February 15, 2016

Cross City Cycling Routes
City Deal Team,
SH1311, Shire Hall,
Cambridge CB3 0AP

Response to the City Deal Cross City Cycling Consultation

Appendix 1 – Diagrams of recommendations for Fulbourn/Cherry Hinton Eastern Access (Route E).

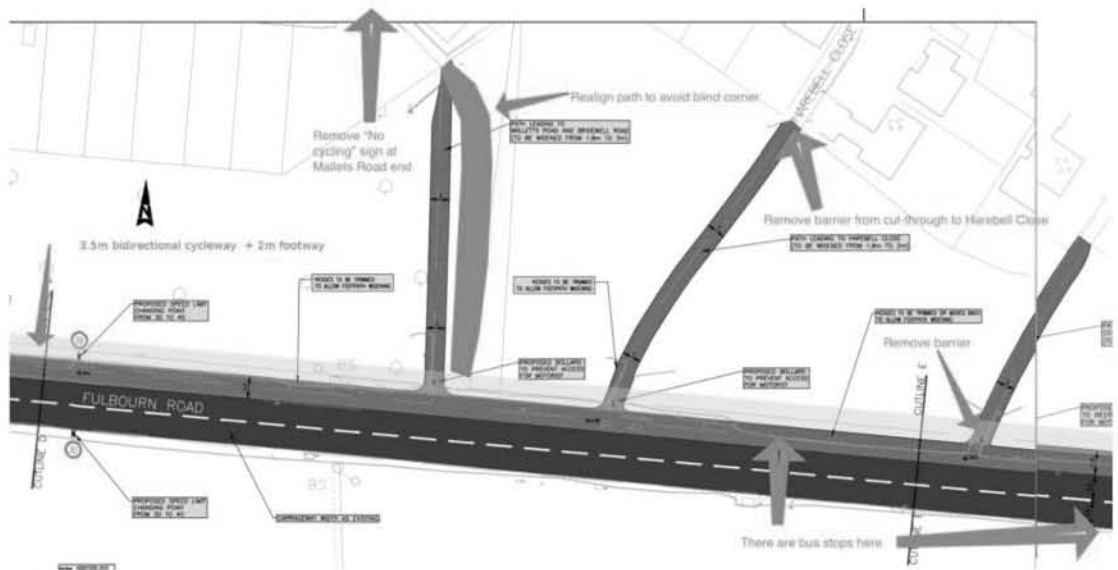
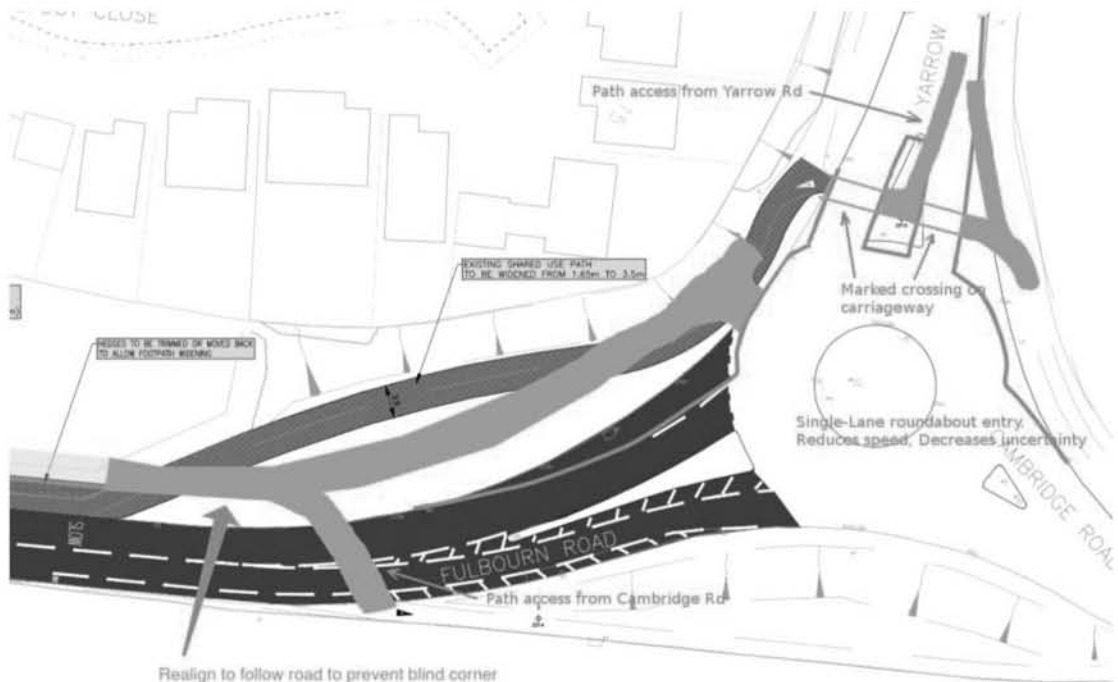
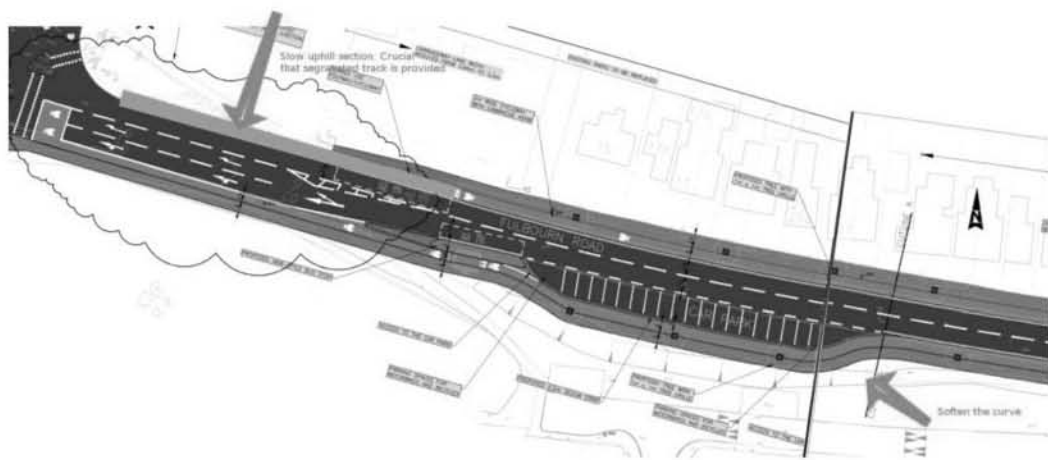
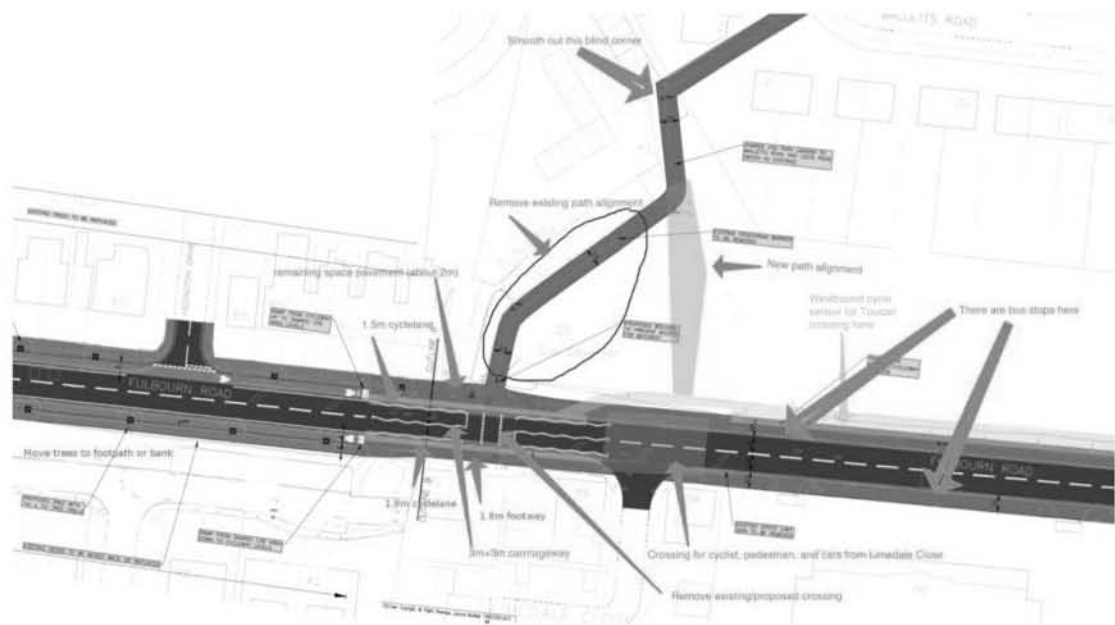
The path from Leete Rd can be re-aligned easily to come to this point, and that will remove a blind corner. There is plenty of space to arrange for people waiting to cross and those continuing past.

- There is no provision for cyclists on-road on Cambridge Road or Yarrow Road, not even a painted lane on Fulbourn Road, nor an easy way to join the bidirectional track from the roundabout. The crossing alignment needs to be changed to allow this movement from Yarrow Road, and either a flush kerb at the roundabout or a marked unsignalised crossing from the end of the roundabout bypass.
- There is a blind corner at the east end of the hedge. The cycleway alignment should be smoothed out here to remove this corner (See diagram in Appendix 1).
- The 3m shared-use proposed at the side paths to the estate is sufficient. The exits at Fulbourn Road should be flared to provide 5 metre radius turns (see LTN 2/08 table 8.1). The proposed bollards are unnecessary at this point as there is no dropped kerb - no motor vehicle will be trying to go this way.

- The path to Mallets Road should be realigned to remove the blind corner (See diagram in Appendix 1). The no-cycling sign at the end of Mallets Road should be removed. The barrier at cut-through to Harebell Close should be removed.
- Many pedestrians and some cyclists from the east heading for the east end of Peterhouse Technology Park will use the uncontrolled crossing at the Park. The island must be wide enough to accommodate a cycle. The proposed 2m is sufficient.
- There is currently extremely poor visibility on the path at the blind corner of Leete Road and Limedale Close. Removing the barrier as proposed will help a lot but

- The pram arms barriers at the Leete Road end of the path to the signalised crossing must be removed and a flush kerb with a smooth transition added.
- The segregated route starts/ends 40m west of Limedale Close. Consideration should be given to extending the segregation to the Limedale Close junction, even though space is limited on the south side. By reducing the south carriageway to 3m on this section there is room for 1.6m footway and 1.6m segregated cycleway, which might be more effective than a 3m shared-use section over this short distance.

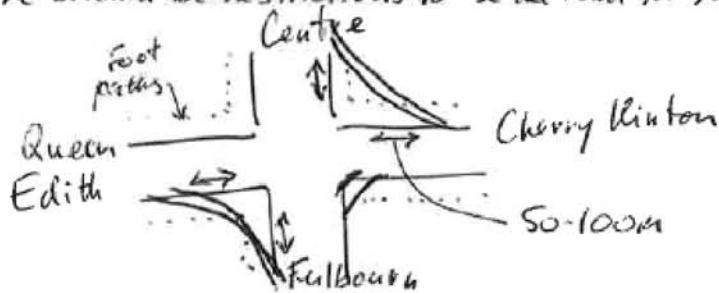
If you observe the cyclists crossing the junction you will find that the vast majority cross diagonally, a few going up Hong Road, the majority to the hospital. Very few go straight across Hills Road towards the hospital.

The proposal to make cyclists go straight across is doomed to failure. Cyclists most often take the shortest route.

What should be done is to create extra waiting area space, create a priority crossing with the traffic lights allowing cyclists to cross diagonally across the junction
